T950093

FROM:	MIKE ZUCKER
ORGANIZATION:	
FAX NUMBER:	617 253 7014
VOICE NUMBER:	617 253 8070
REFER TO:	LIGO-195 — LIGO-T950093-00-D
SUBJECT:	HAM ISOLATION STAY-CLEAR

ME 2 SUGGESTED BOUNDARY
HAM CHAMBER, BOTTOM VIEW

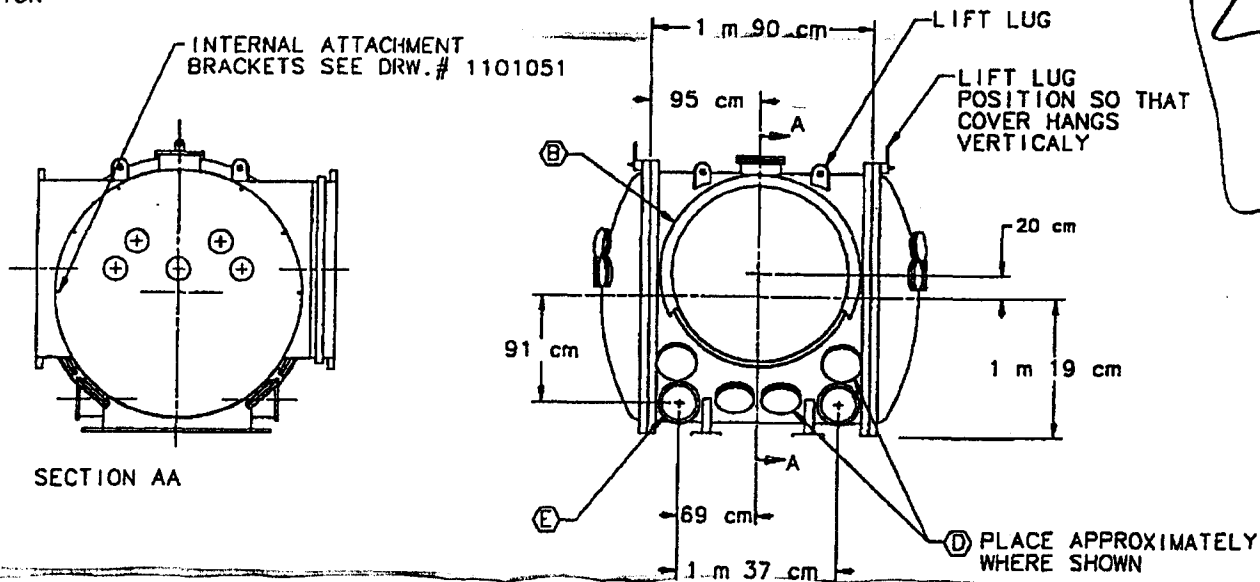
NOTE: Here is our spec, PSI's "old" design,
 and my proposed confinement of their
 supports to the central $\sim 1.7 \times 1.7$ m
 rectangle. Talk w/gov tomorrow.
